Santa Cruz County Advisory Panel on the South32 Hermosa Project
Santa Cruz County Provisional Community College District, 2021 N Grand Ave, Nogales, AZ 85621

Meeting Minutes for January 17, 2024
Santa Cruz County Advisory Panel on the South 32 Hermosa Project
Santa Cruz County Provisional Community College District, 2021 N Grand Ave, Nogales, AZ 85621

4.1. Patagonia Area Resource Alliance (PARA) (Attachment 3) – Carolyn: I provided the comments to ADEQ to everybody. In the interest of time. I won't add anything to it other than saying there is an update. We received notice that in the federal case an oral argument hearing is scheduled for March 25.

| <p>AZPDES Draft Fact Sheet at 6 (Nov. 28, 2018)</p> |

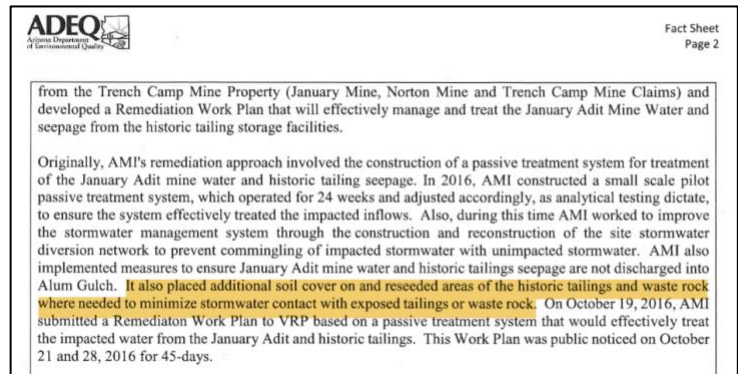
ADEQ states that these restrictions are to ensure “that no new sources will be discharged to an impaired water as required by the *San Carlos* decision.” (Draft Fact Sheet at 6).²⁷

²⁷ Inexplicably, ADEQ also states: “If 100% reuse is not possible, effluent from WTP1 may be discharged from Outfall 001 to Upper Alum Gulch...” Draft Fact Sheet at 3. Presumably this means that drainage from non-historic sources may be discharged from Outfall 001

AZPDES No. AZ0026387 Draft Fact Sheet at 2 (Jan. 2018), emphasis added

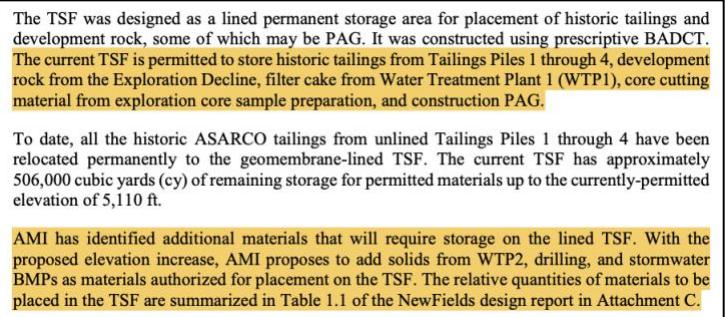
The 2018 Fact Sheet for the initial issuance of this AZPDES Permit (above, left) plainly states that historic tailings materials were commingled with additional materials containing new sources of pollution, such as soil and waste rock since at least 2016, even before the old historic unlined tailings piles were moved and restructured into the current TSF.

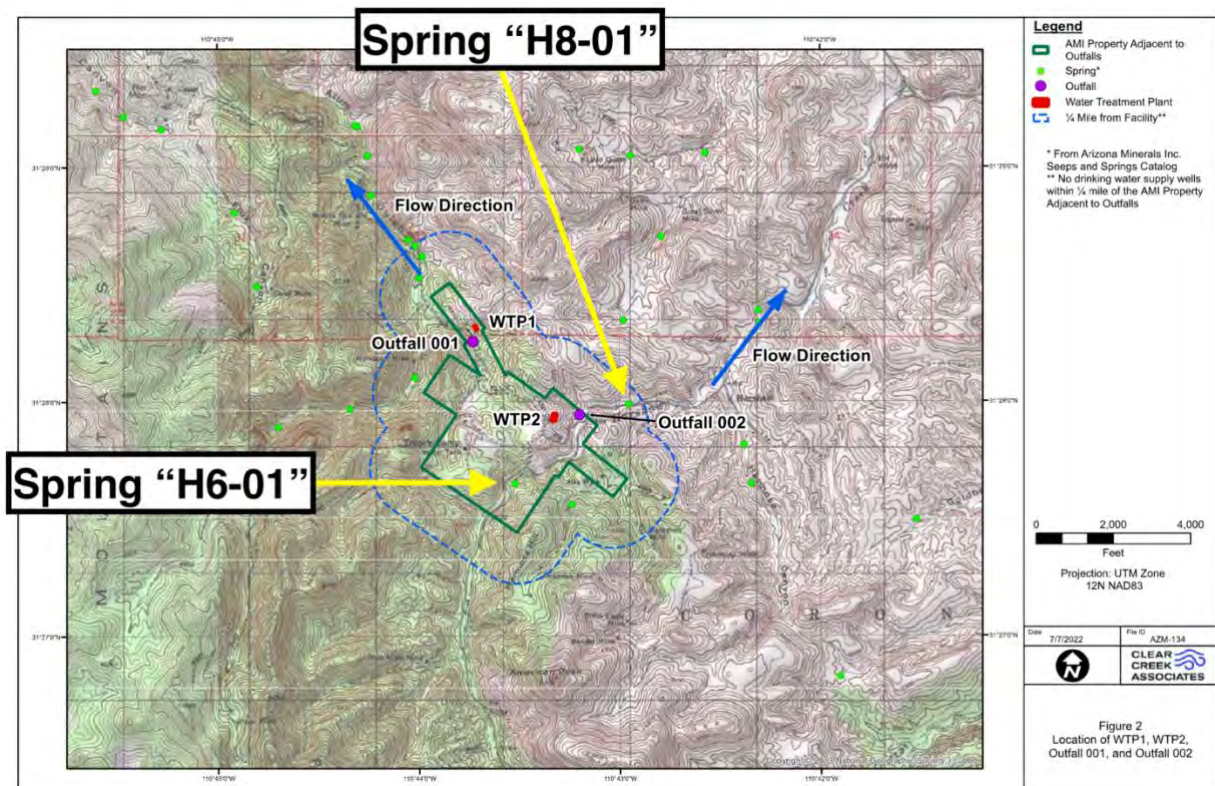
Below - Figure 2 from South32 (formerly Arizona Minerals)’s Application for Reissuance of AZPDES Permit dated July 11, 2022 (annotations added). Outfall 002 is south of (upstream of) H8-01.

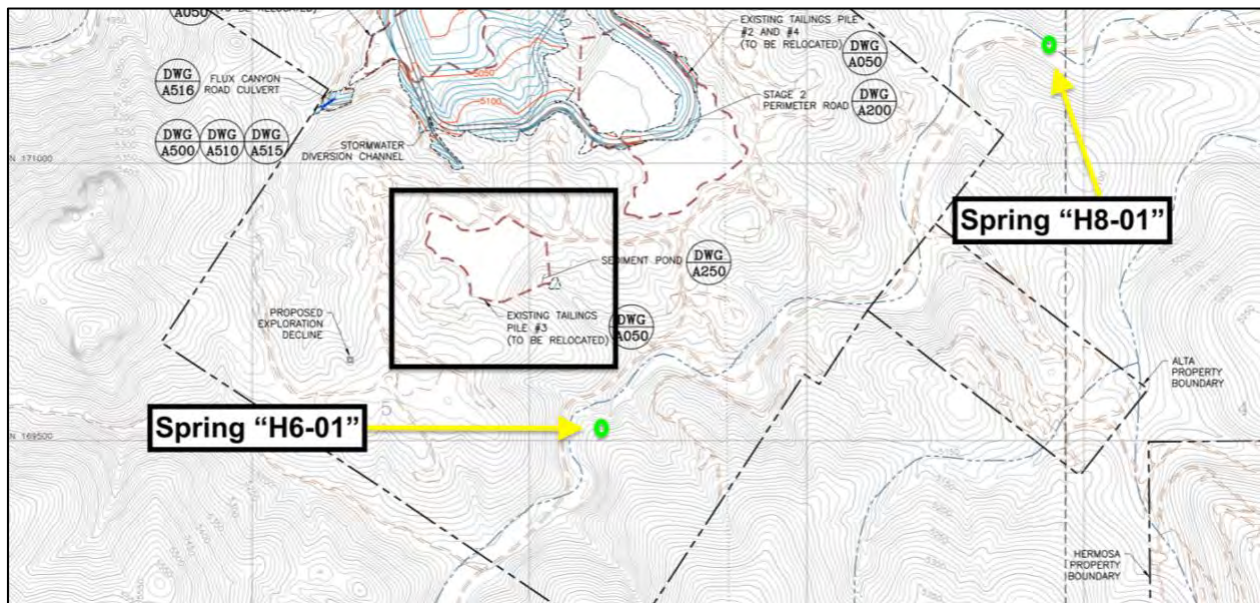
own description in the 2003 TMDL. See below (excerpt of Figure 3 from Arizona Minerals, Inc.'s Aquifer Protection Permit Application, Trench Camp Property dated June 5, 2017).

Figure 4. ADEQ flow regime classifications.

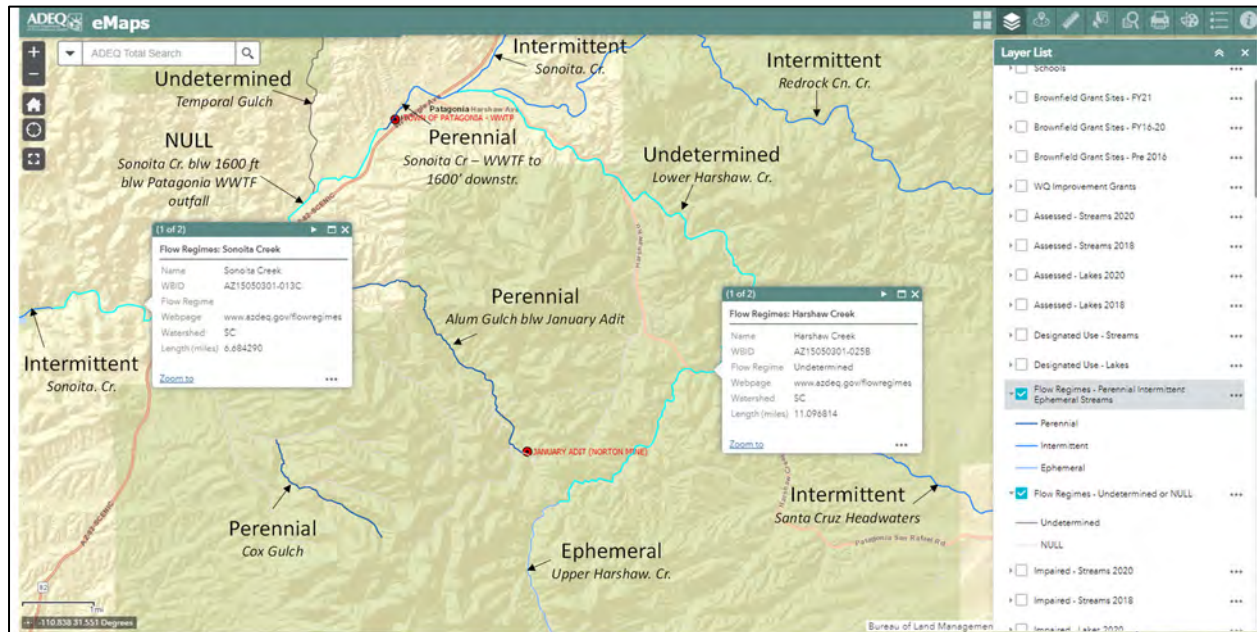
Figure 4 shows the current ADEQ “Flow Regimes” (perennial, intermittent, ephemeral, undetermined, and null) for the Patagonia Mountains in the area south of the Town of Patagonia. Each colored stream in the figure is labeled with its ADEQ Flow Regime classification. Notably, Sonoita Creek through the TNC preserve has no classification (“NULL”) and lower Harshaw Creek and Temporal Gulch are “Undetermined.”

The satellite image in Figure 3 and evidence from the TNC preserve provided above suggest that most of the Sonoita Creek reach listed as “NULL” on the ADEQ Flow Regimes map is perennial. ADEQ classifies the flow regime of upper Harshaw Creek as ephemeral, but they have made no determination for lower Harshaw Creek. Inexplicably, ADEQ changed the classification for Harshaw Creek from perennial to ephemeral in 2002, during one of the driest water years on record at that point (ADEQ, 2003a). Several sources cite intermittent and even perennial flow in lower Harshaw Creek, as discussed below.

Figure 6. ADEQ Permits In Process map showing Harshaw Creek as intermittent (<https://adeq.maps.arcgis.com/apps/webappviewer/index.html?id=13c7ddd647304520aa56b99aef3dce47> accessed April 5, 2021).

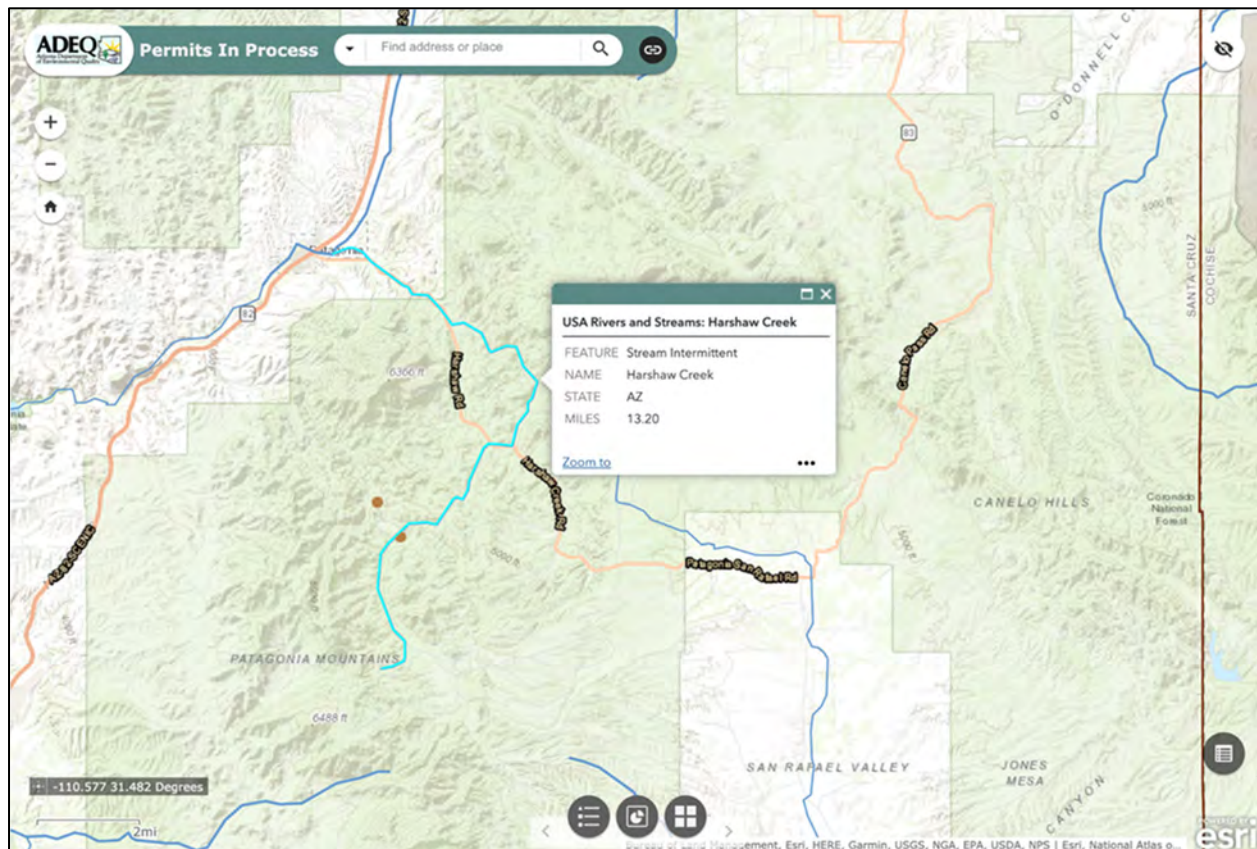
intermittent and the ADEQ’s designated use code as Aquatic and Wildlife- ephemeral (A&We). However, the ADEQ’s own “Permits in Process” website shows the entire 13.20-mile length of Harshaw Creek as intermittent (Figure 6). Furthermore, ADEQ concluded in its Draft Statement of Basis for the Draft Permit at 2 that “Application of the NWPR [Navigable Waters Protection Rule] Screening Toolkit shows that a portion of Harshaw Creek is “likely a water of the U.S. (WOTUS). Thus, the facility’s discharge to Outfall 002 to Harshaw Creek is a point source discharge requiring an AZPDES permit” (ADEQ, 2021b).

Figure 7. National Wetlands Inventory map of lower Harshaw Creek.

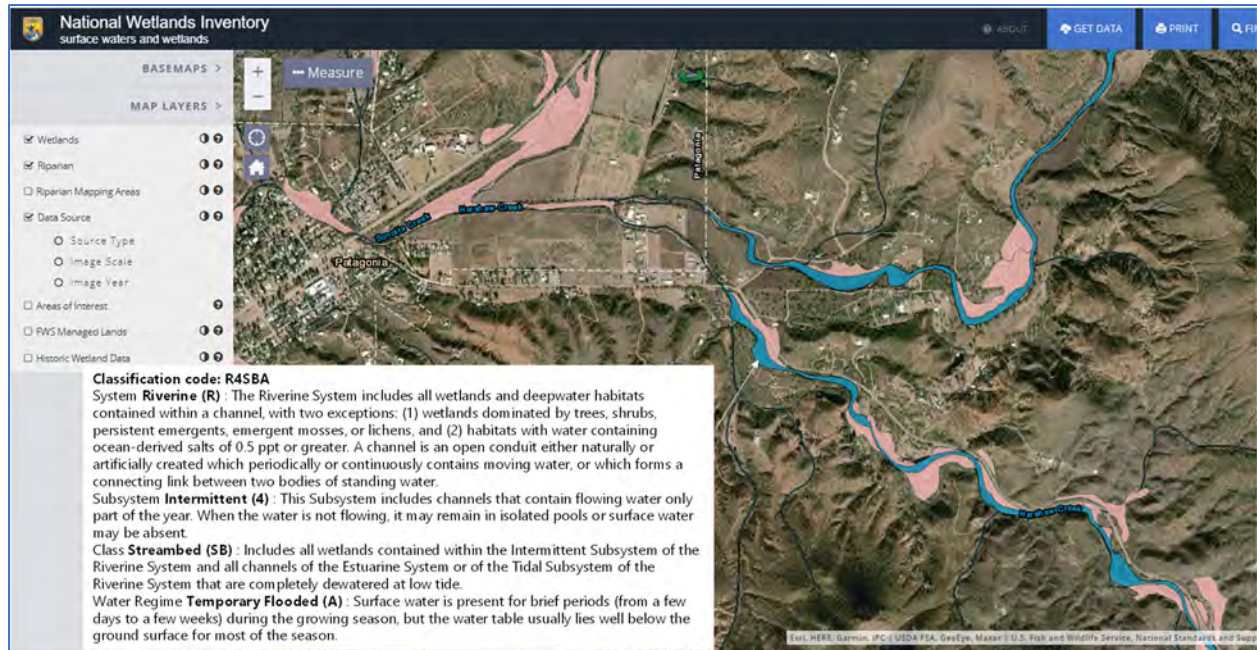
Figure 7 shows the National Wetlands Inventory map for lower Harshaw and Redrock Canyon creeks. The blue shaded areas represent Classification Code R4SBA: Riverine, Intermittent, Streambed, Temporary Flooded (see text inset in Figure 7 for more detail). Thus, despite a lack of regulatory consensus on its flow regime as ephemeral or intermittent, lower Harshaw Creek does contain significant riparian habitat. ADEQ’s lack of a perennial designation of Sonoita Creek downstream of 1600 ft below the Patagonia WWTF outfall, however, is wholly inconsistent with clear evidence that this reach is perennial and supports one of the mostly highly valued ecosystems in the region.

Figure 10. 2020 assessment of Sonoita Creek below 1600 ft below the Patagonia WWTF outfall.

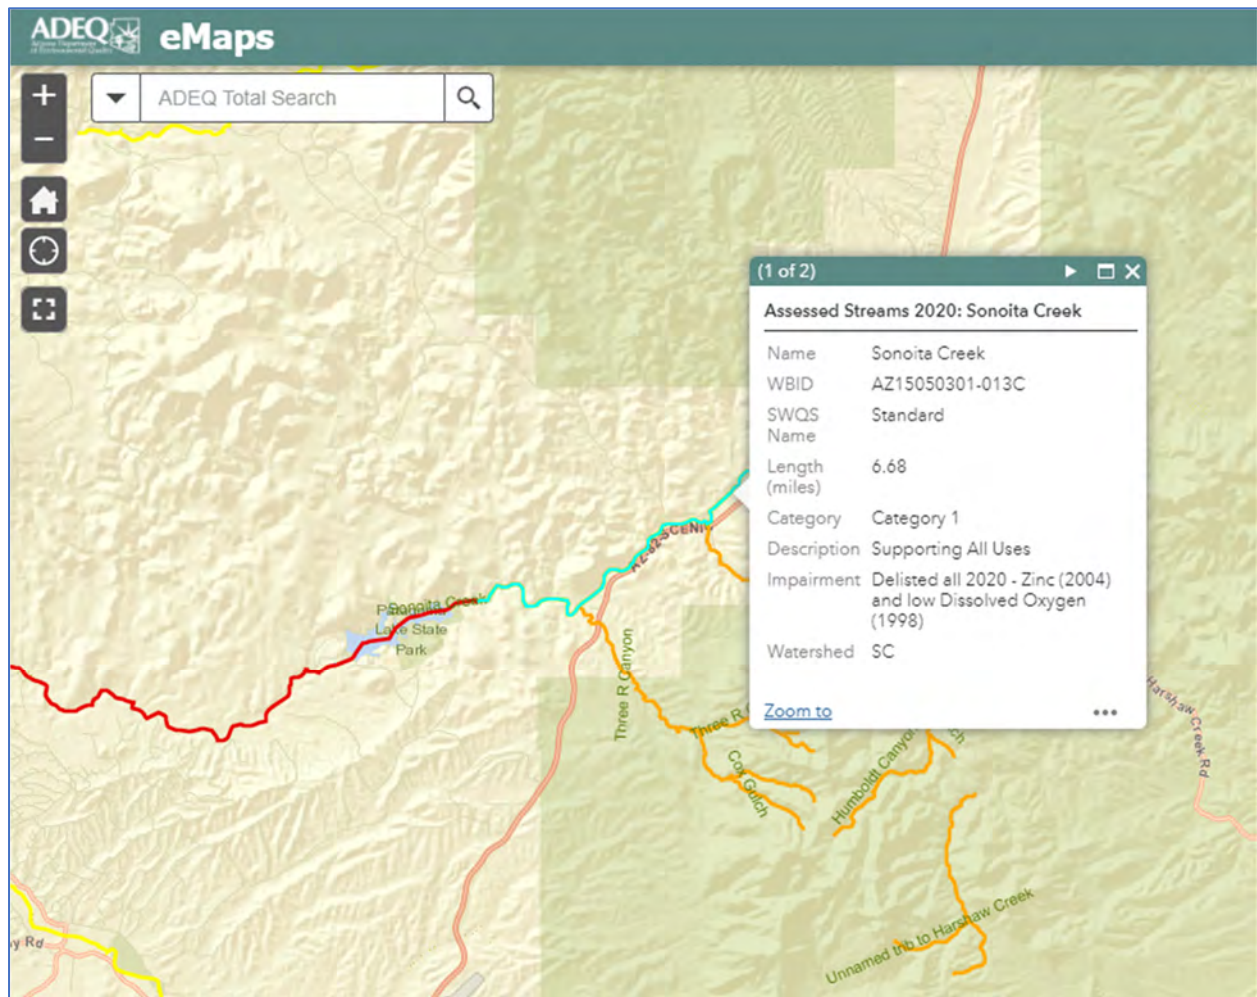
for “Assessed/Impaired Lakes/Streams 2020” indicating that they are in draft form. While this draft map indicates that this reach was delisted for zinc and low dissolved oxygen in 2020 (Figure 10), and so now qualifies for Tier 2 protection, no other documentation of the delisting of Sonoita Creek for its previous impairments in zinc and dissolved oxygen are available. If this reach, in fact, remains “impaired” under Section 304(d) for zinc and dissolved oxygen, then it still qualifies for Tier 1 protection permitting no further degradation.

Figure 15. AMI's delineated Discharge Impact Area and Pollutant Management Area for the Hermosa Project (Clear Creek Associates, 2020).

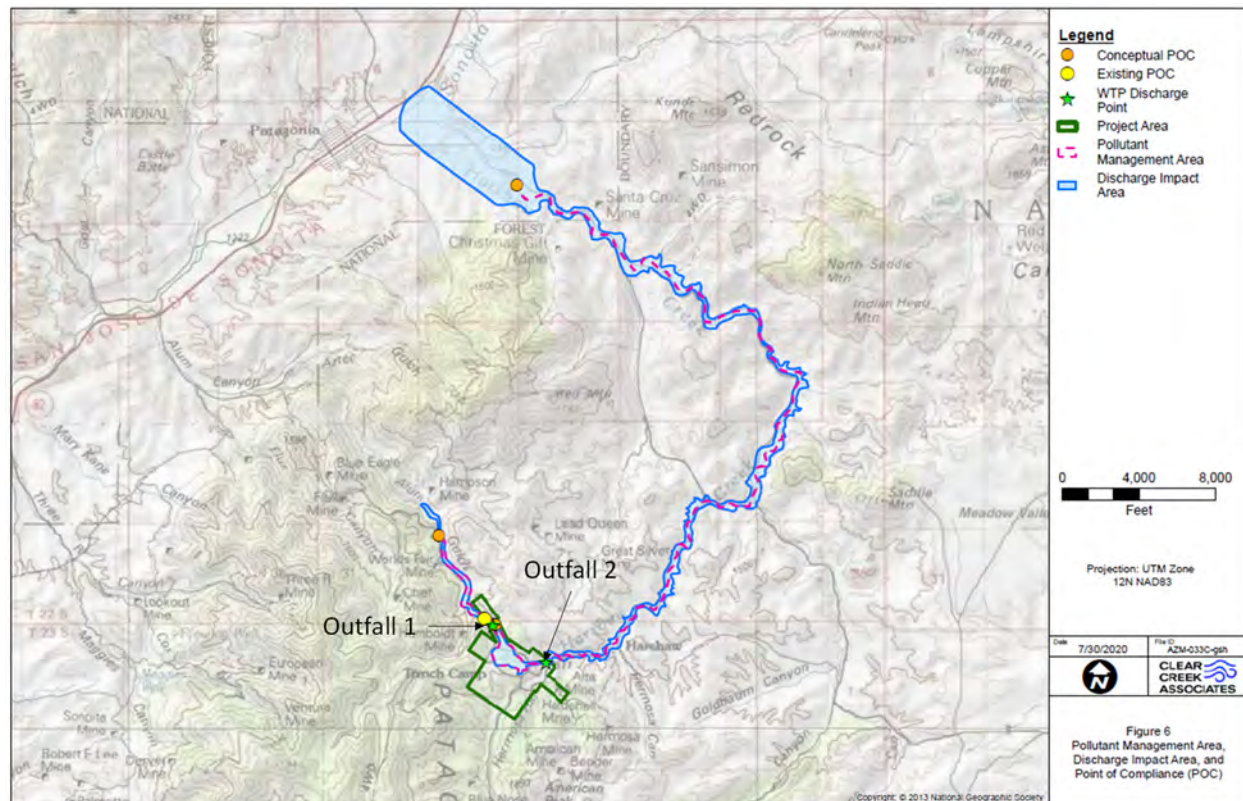
This 9.4-mile distance became the basis for AMI's delineated "Discharge Impact Area (DIA)" and "Pollutant Management Area (PMA)" (Figure 15) downstream of WTP2 (Clear Creek Associates, 2020). The authors of the DIA and PMA delineation study used an analytical (vs. physical) model and note that, "... the analysis does not assess transient events or changes in streambed or aquifer storage over time" (Clear Creek Associates, 2020, p.18).

Figure 20. Simulated discharge at the TNC Patagonia-Sonoita Creek Preserve with and without 4 years of 4500 gpm discharge at WTP2.

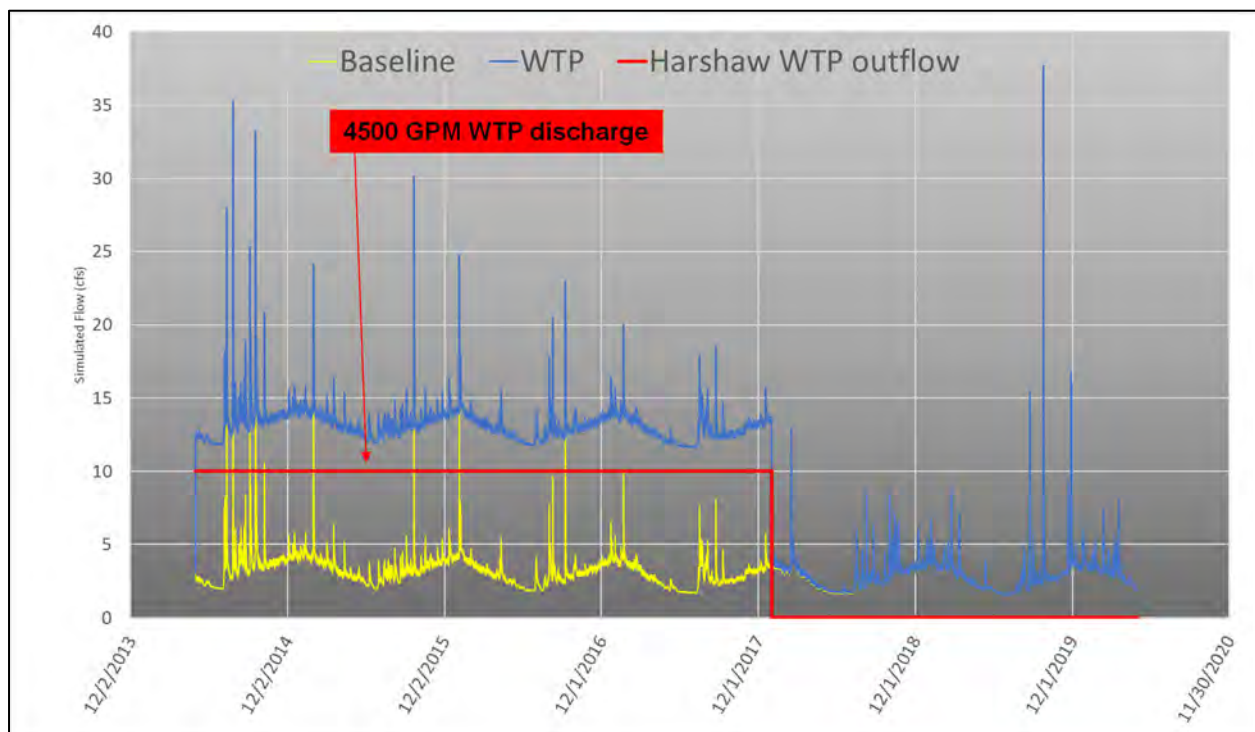
Figure 20 illustrates simulated discharge at the TNC Patagonia-Sonoita Creek Preserve under baseline conditions (yellow) and with 4500 gpm of discharge from WTP2 for roughly four years. This graphic shows that after only a little over a month of wetting up the channel and local aquifer system, the added WTP2 discharge is conveyed with virtually no loss (not accounting for evapotranspiration increases over time) from WTP2 through town and down to the TNC preserve. The size of the storm peaks with the additional WTP2 discharge is augmented due to the lack of unsaturated zone storage capacity resulting from shallow groundwater and shallow bedrock in Harshaw Creek; thus storm flows are “rejected” from the groundwater system rather than being able to infiltrate the way they could under baseline conditions. This hydrologic behavior is supported by Schrag-Toso’s (2020) assessment that, “...the thin veneer of stream channel sediments appears to be a conduit of groundwater flow, moving groundwater discharged from the fracture system mixed with recent precipitation towards the Sonoita Creek basin.”
